PLANNING BOARD AGENDA
MARCH 12, 2014 - 7:00 P.M.

Re: CVS - Carmel TM# 55.10-1-12

VHB is pleased to submit these responses to your January 23, 2014 memo.

Re: **Supplemental Update to**
Stormwater Management Memorandum
CVS/ pharmacy, Carmel, NY

Yanasee Hanger Brustlin, Inc.
 Figure 2
 Existing Conditions
 Drainage Areas
 1906 Route 6
 Carnel, New York
 January 8, 2014

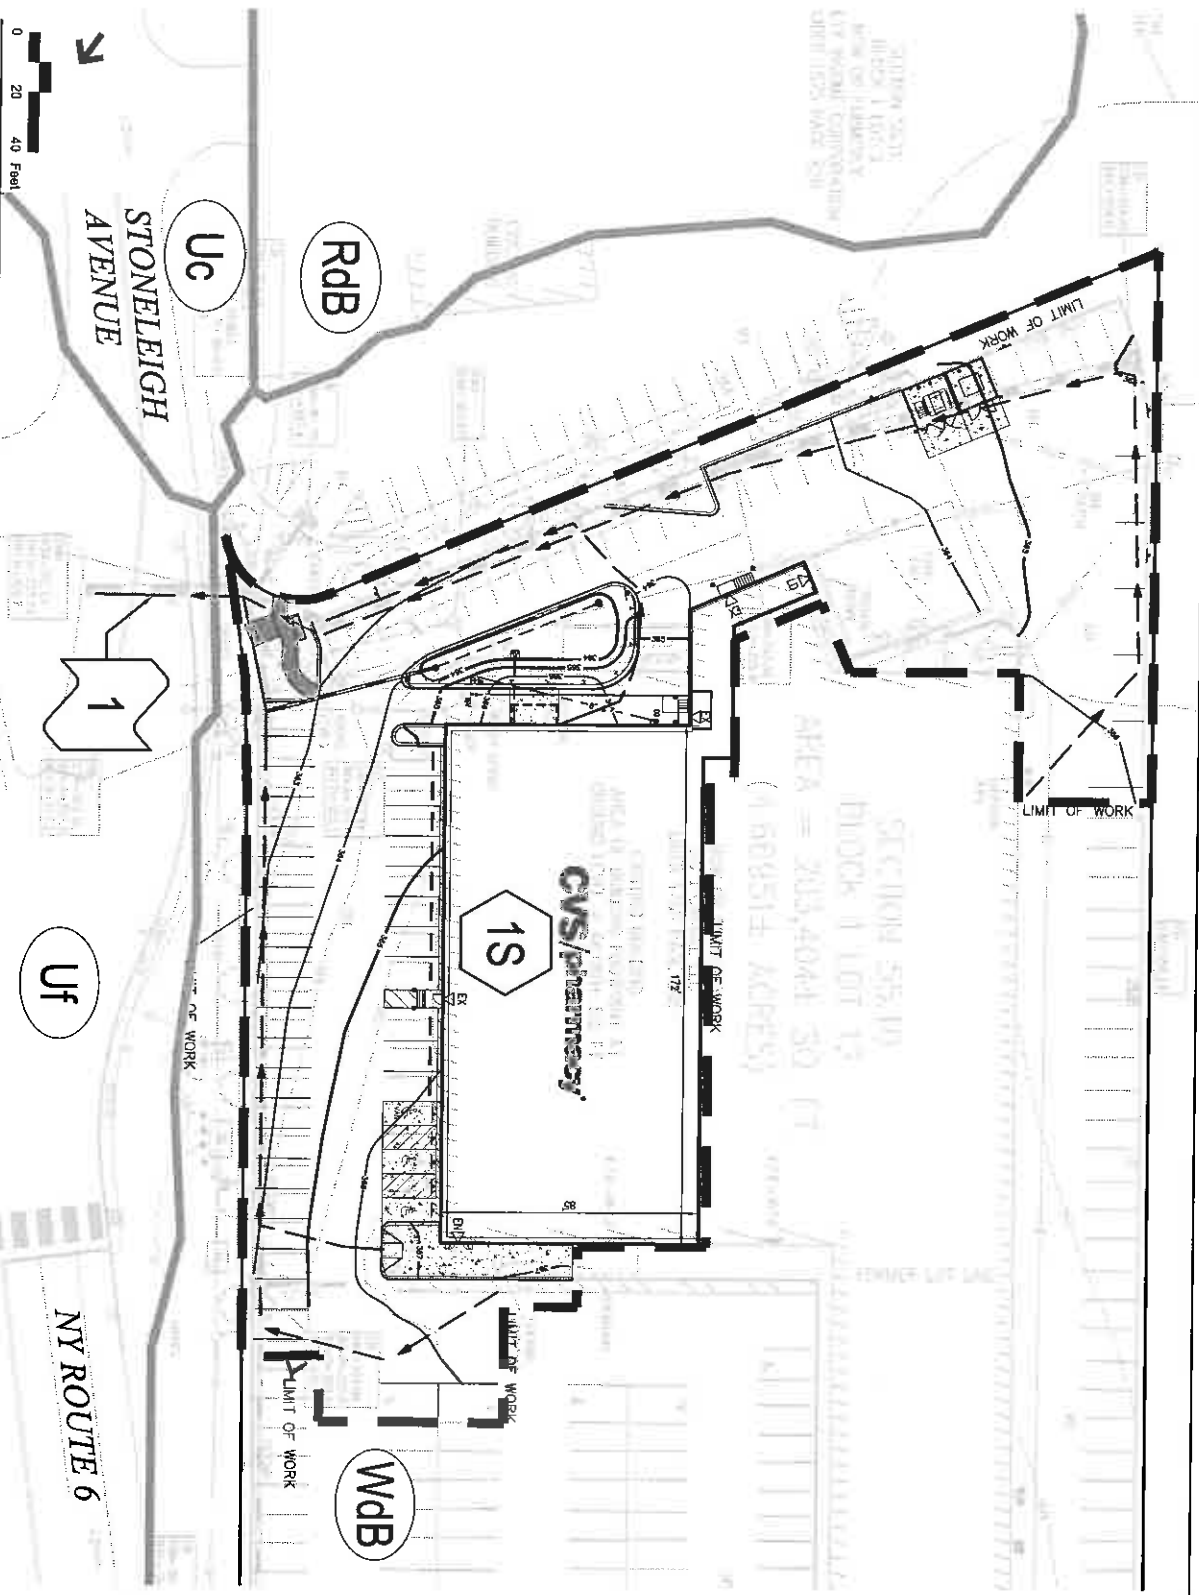
Comment 3: The Stormwater flow patterns should be provided.

Response: Additional Time of Concentration lines have been added to Figure 2 and Figure 3 (included with this letter) which represent flow patterns for the new development area. All stormwater drainage from this southern redevelopment enters the onsite catch basins which convey stormwater offsite into the State system via the onsite closed pipe network.

Updated Figures 2 and 3 (existing and proposed conditions drainage areas) are included in the Appendix. Additional time-of-concentration lines have been added to the figures to represent existing and proposed drainage patterns within the redevelopment area.

PROPOSED SIGN PACKAGE

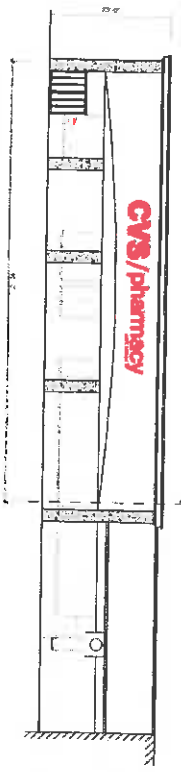
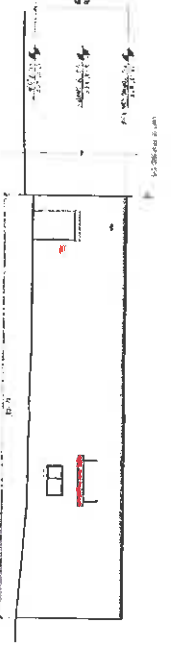
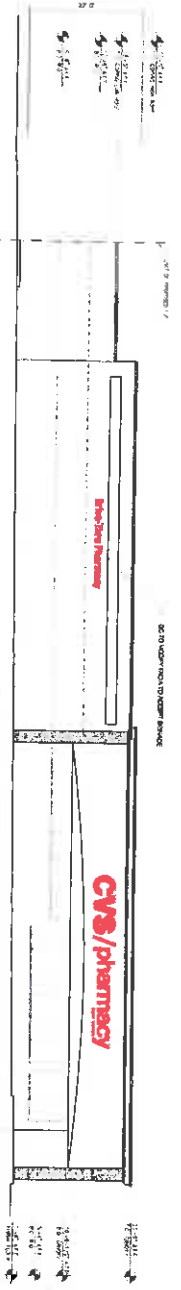
Comment 2: Variances are required for signage. Only one sign is permitted per establishment per frontage on a town, county, or state road.

- **Comment:** Clarify signage lighting.

Response: Understood. The applicant requests to be referred to the Zoning Board of Appeals.

Response: The signage will be internally lit LED illuminated channel letters. The updated sign package is included.

PROJECT NUMBER: 0033021
 DRAWING NUMBER: 1000
 DATE: 1/16/2004
 CS NUMBER: 0033021
 Vehicle Turning Movement
 Passenger Vehicle

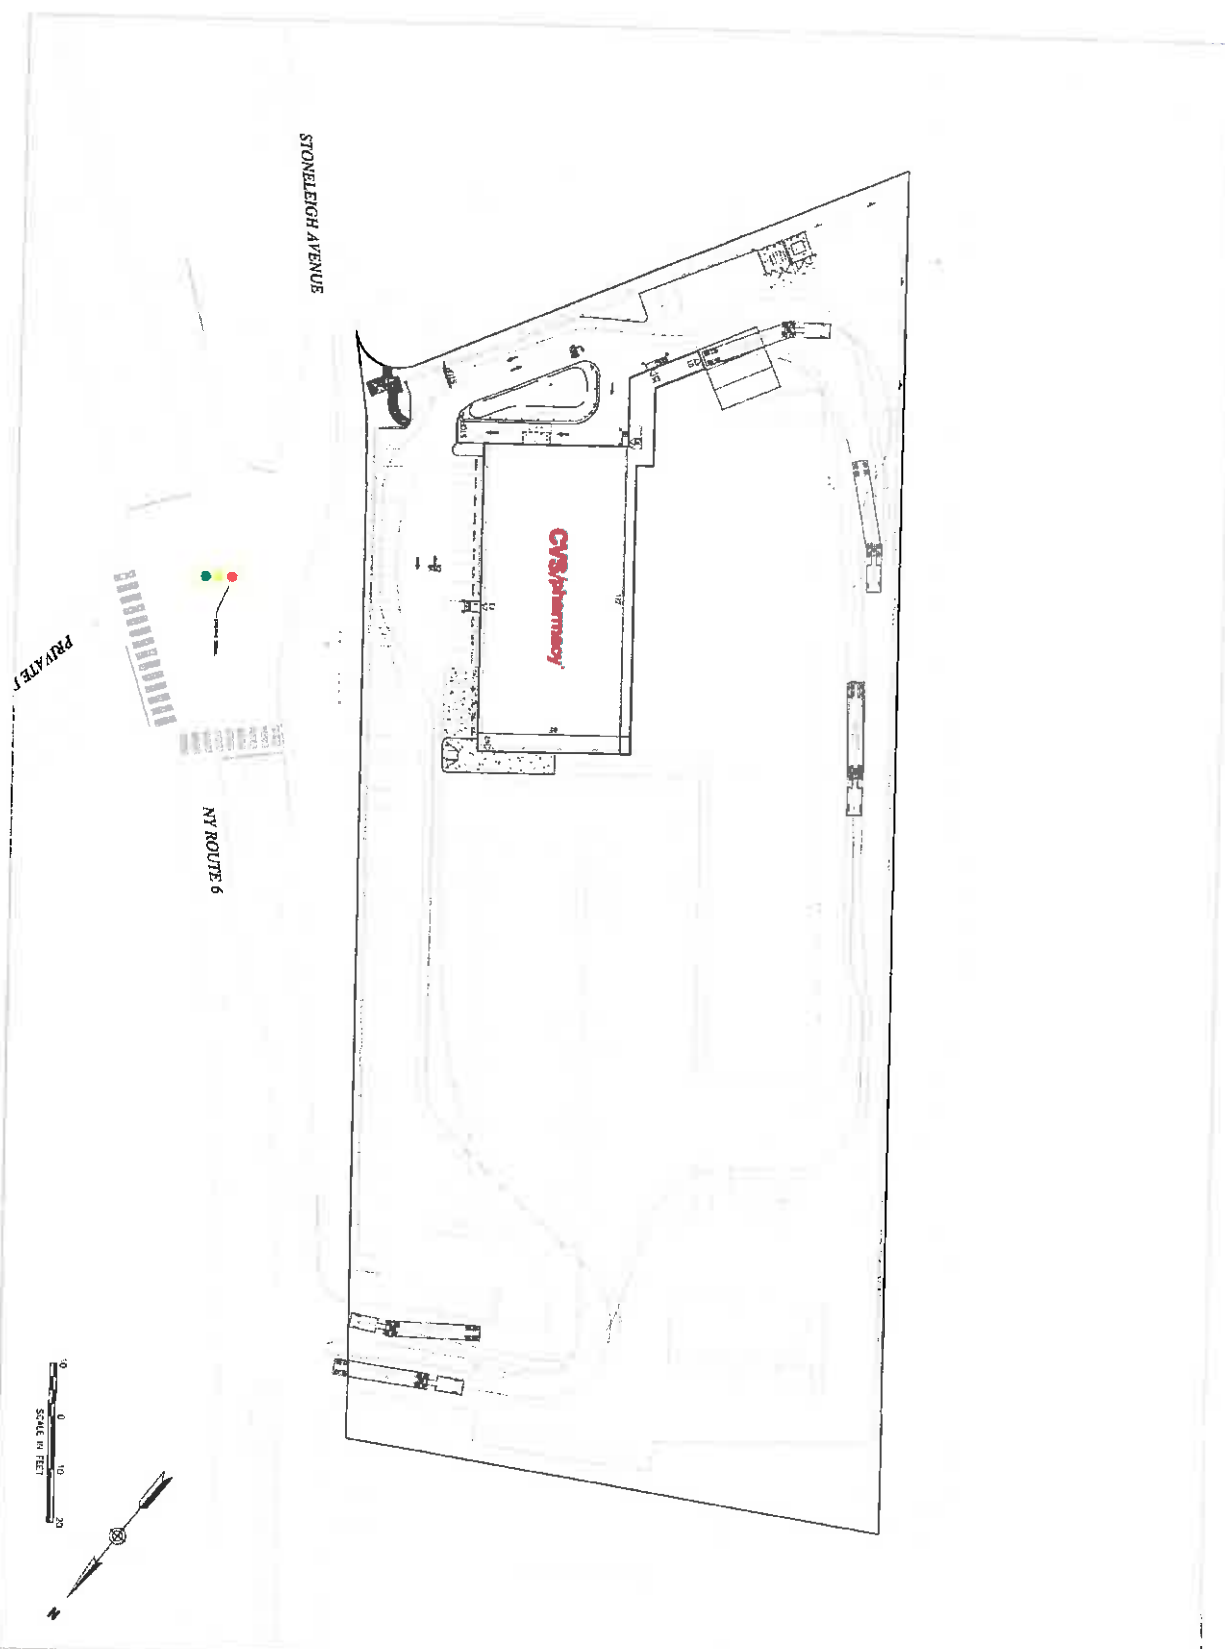
Comment 3: Graphic representation of vehicle movements through the site should be provided to illustrate that sufficient space exists to maneuver vehicle attempting to enter the drive-thru as intended. The turning radius to enter the drive-thru should be provided.

- **Comment:** The geometry of the drive-thru turning movements should be documented, including turning radii, queue length, etc.

Response: Turn Template exhibits 1 and 2 have been prepared and demonstrate the travel paths for delivery vehicles to and from the loading dock and customer vehicles to and from the drive-thru. The turning radius has been provided on the drive-thru template. Given the typical low volume at the drive-thru and lower speeds entering the drive-thru the turn radius is appropriate for the entering vehicles.

Response: Included with this letter is sheet TT-1 titled "Vehicle Turning Movement, Passenger Vehicle" which shows a passenger vehicle navigating through the drive-thru lane. Turning radii are shown on the plan as well as four (4) queued vehicles, including one (1) vehicle at the drive-thru window. Given the typical low volume at the drive-thru and lower speeds entering the drive-thru the turn radius is appropriate for the entering vehicles.
